Addendum 1 Solicitation 20-99379 Piedmont Rec Area Green Infrastructure Improvements

This addendum serves to notify all bidders of the following changes to the solicitation documents:

PIEDMONT RECREATIONAL AREA GREEN INFRASTRUCTURE **IMPROVEMENTS**

STATEMENT OF ESTIMATED QUANTITIES PROJ. NO. 17559.000

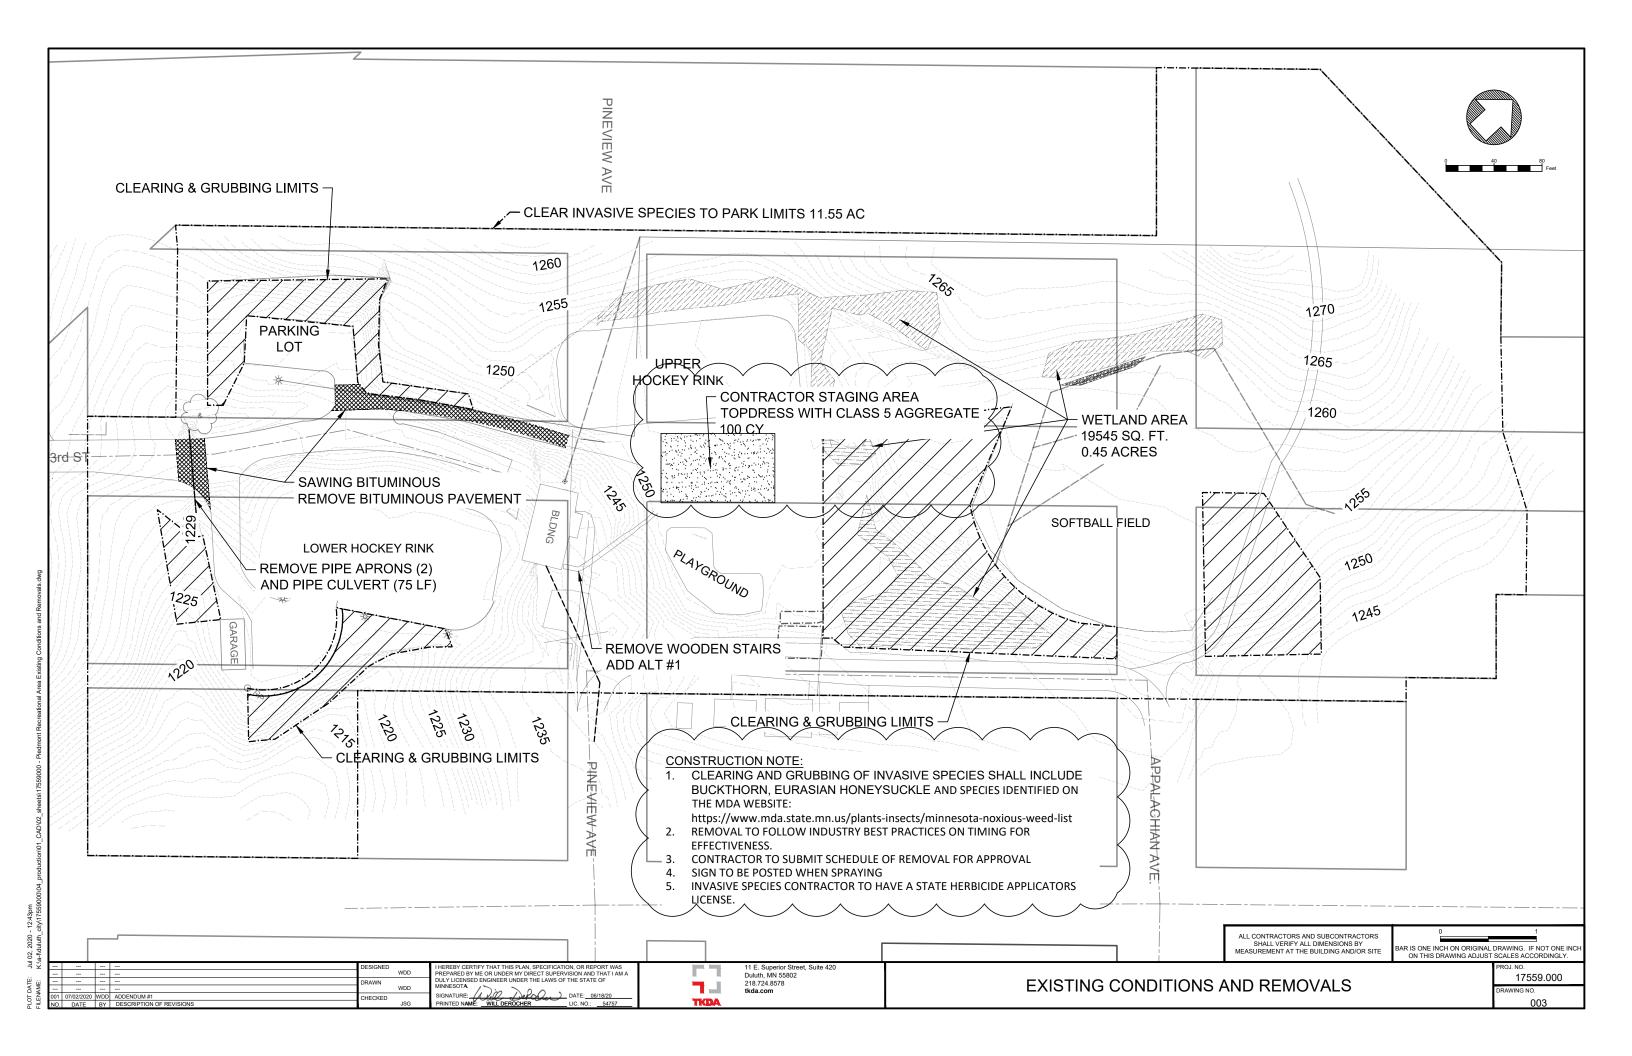
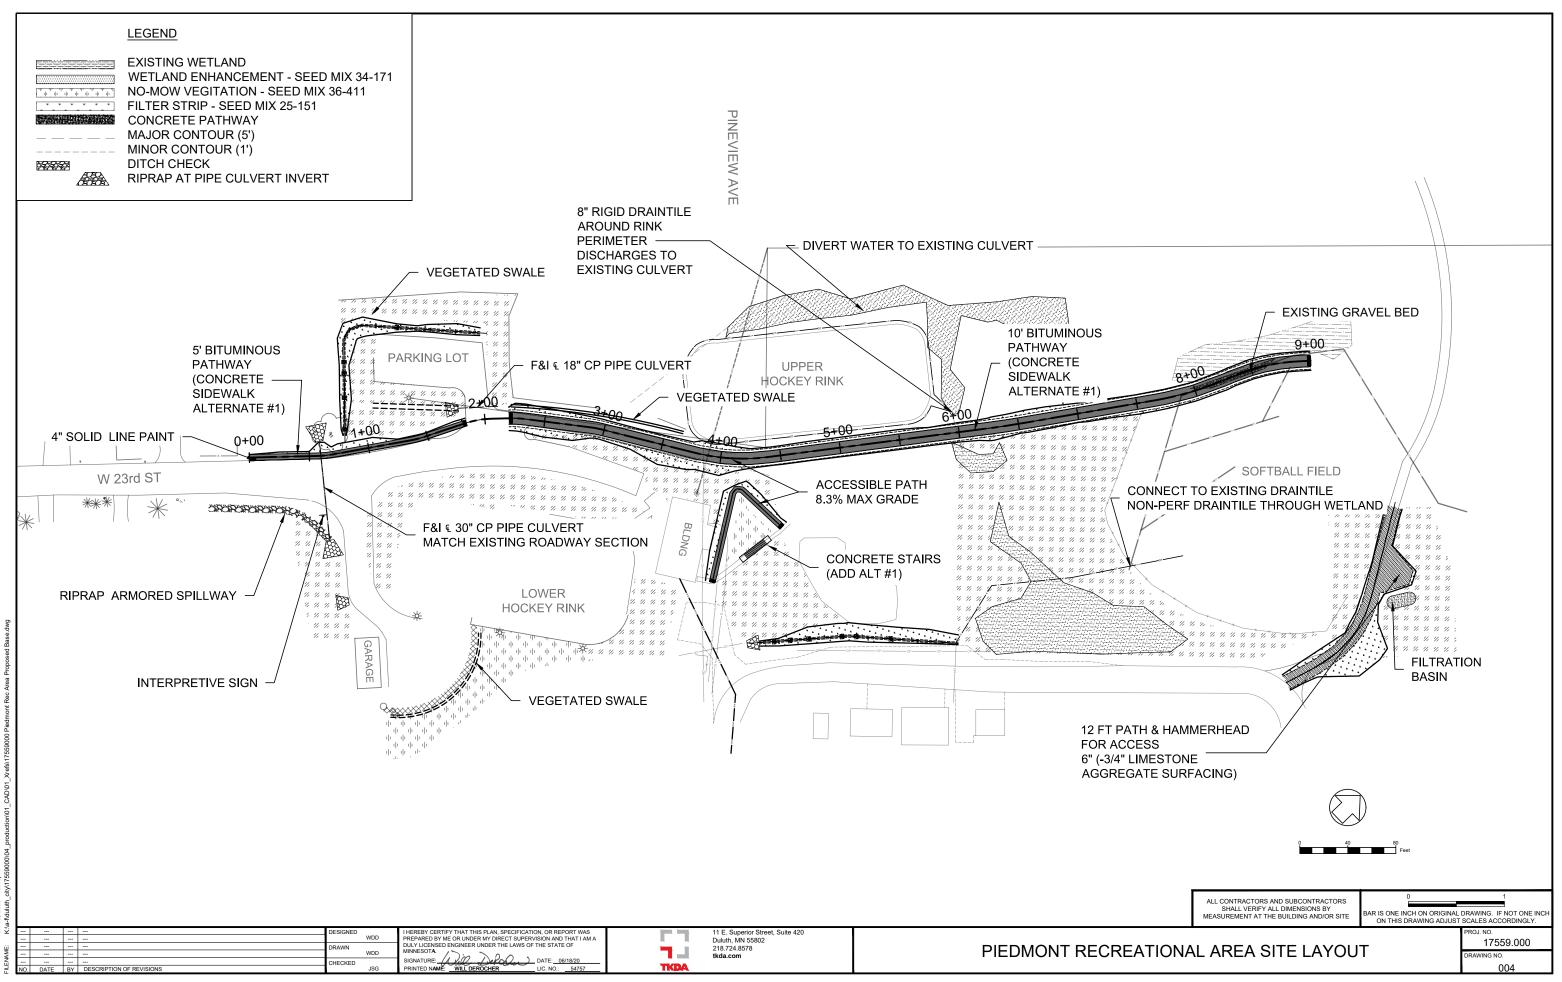
- 3. The upper parking lot is a designated staging area and needs to be top dressed with Class 5.
- 4. Railings have been added to both sides of the ADA accessible route and the concrete stairway of Alternate #1.

- 3.—CONCRETE STAIRWAY ITEM INCLUDES LABOR, MATERIALS, EQUIPMENT AND SUBCUT FOR GROUND PREPARATION. HAND RAILINGS SHALL BE INSTALLED ALONG BOTH SIDES OF THE STAIRCASE AS WELL AS BOTH SIDES OF THE ACCESSIBLE WALKWAY.
